[Docket No. FAA-2006-24074; Directorate Identifier 2005-NM-213-AD]

Airworthiness Directives; Bombardier Model CL-600-2C10 (Regional Jet Series 700, 701, & 702) Airplanes, Model CL-600-2D15 (Regional Jet Series 705) Airplanes, and Model CL-600-2D24 (Regional Jet Series 900) Airplanes

ACTION: Notice of proposed rulemaking (NPRM).

Figure 1
LH side shown
RH side opposite

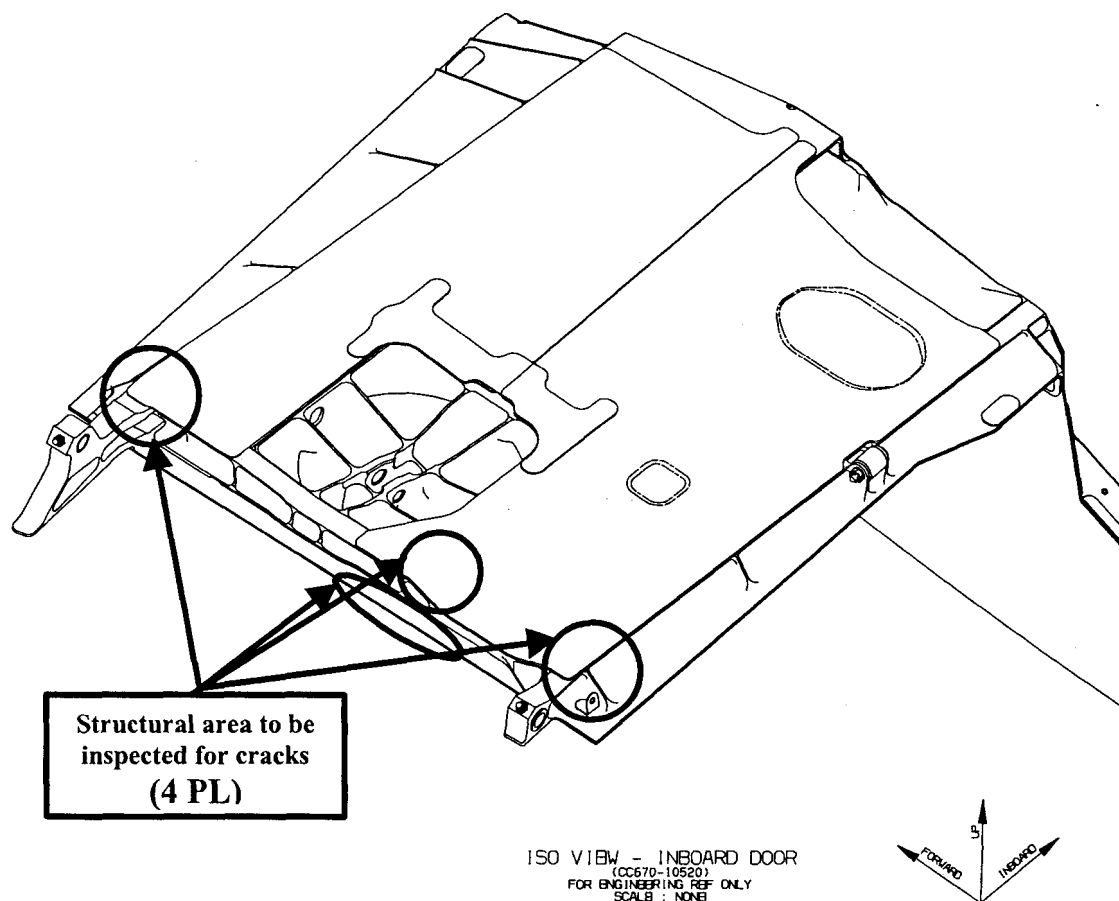
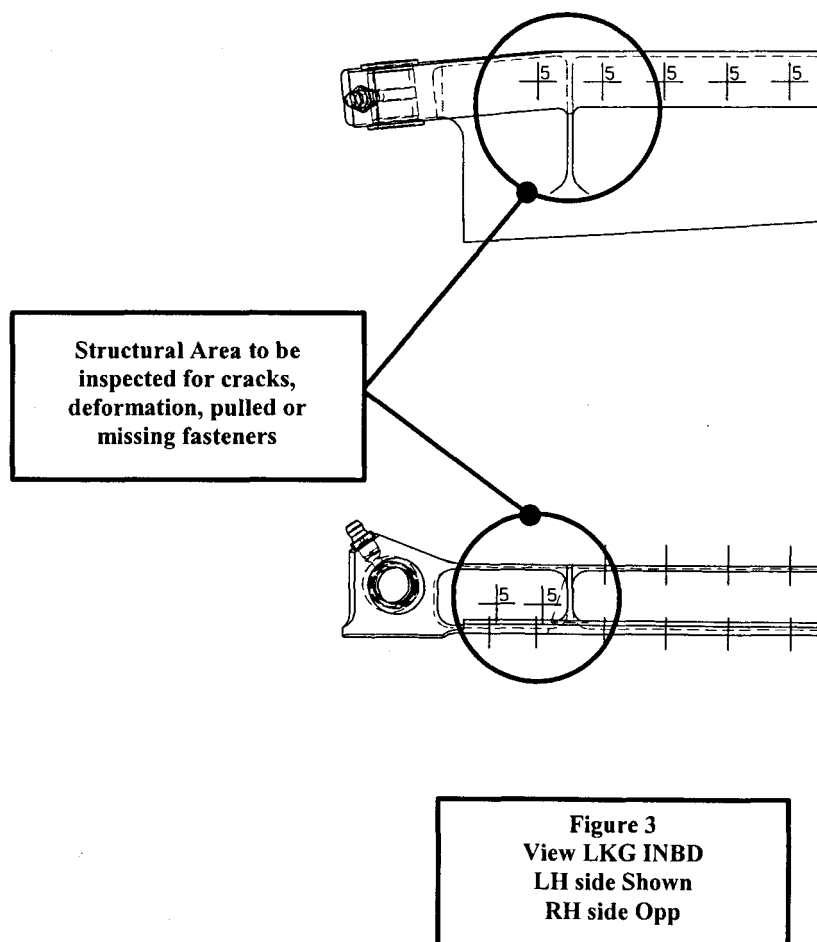
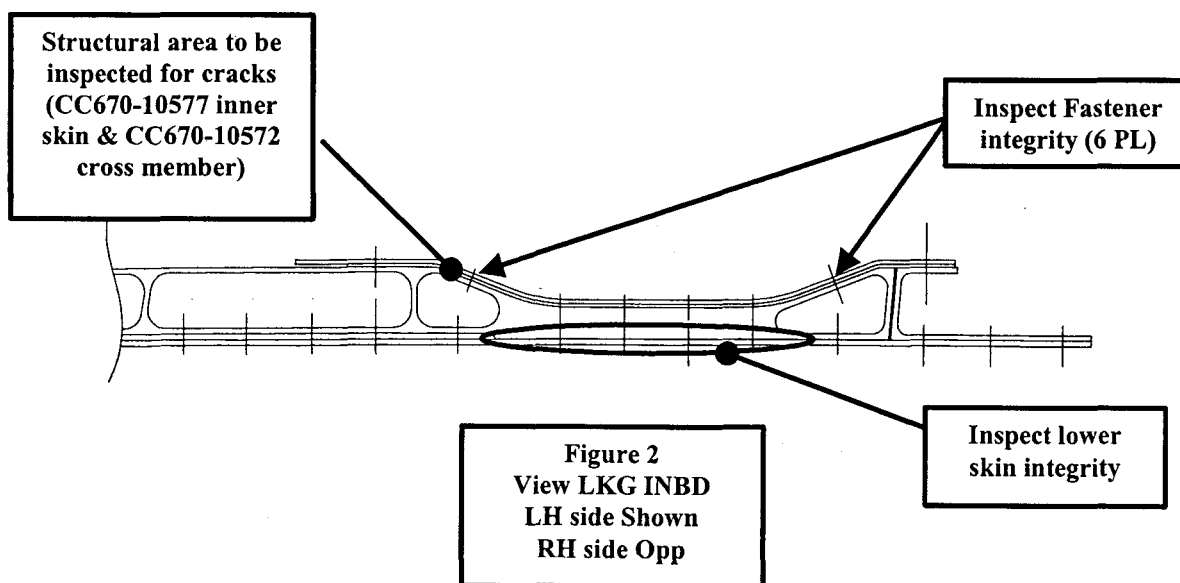
(g) For Model CL-600-2C10 (Regional Jet series 700 & 701) series airplanes, S/Ns 10003 through 10999 inclusive; and Model CL-600-2D24 (Regional Jet series 900) series airplanes, S/Ns 15002 through 15990 inclusive: At the applicable time specified in paragraph (f) of this AD, perform detailed inspections of the lower panel, part number (P/N) CC670-10520, of the left- and right-hand MLG doors for the conditions and in the areas specified in paragraphs (g)(1), (g)(2), (g)(3), and (g)(4) of this AD; and Figures 1, 2, and 3 of this AD.

(1) Inspect the cross member, P/N CC670-10572, of the MLG door lower panel for cracking or deformation, in accordance with Figure 2 of this AD.

(2) Inspect the inner skin, P/N CC670-10577, of the MLG door lower panel at the

cross member (P/N CC670-10572) for cracking or deformation, or pulled or missing fasteners, in accordance with Figure 2 of this AD.

(3) Inspect the outer skin, P/N CC670-10574, of the MLG door lower panel at the cross member (P/N CC670-10572) for cracking or deformation, or pulled or missing

fasteners, in accordance with Figure 2 of this AD.

(4) Inspect the forward member, P/N CC670-10570, and aft member, P/N CC670-10571, of the MLG door lower panel, for cracking or deformation, or pulled or missing fasteners, in accordance with Figure 3 of this AD. Figures 1 through 3 of this AD follow.
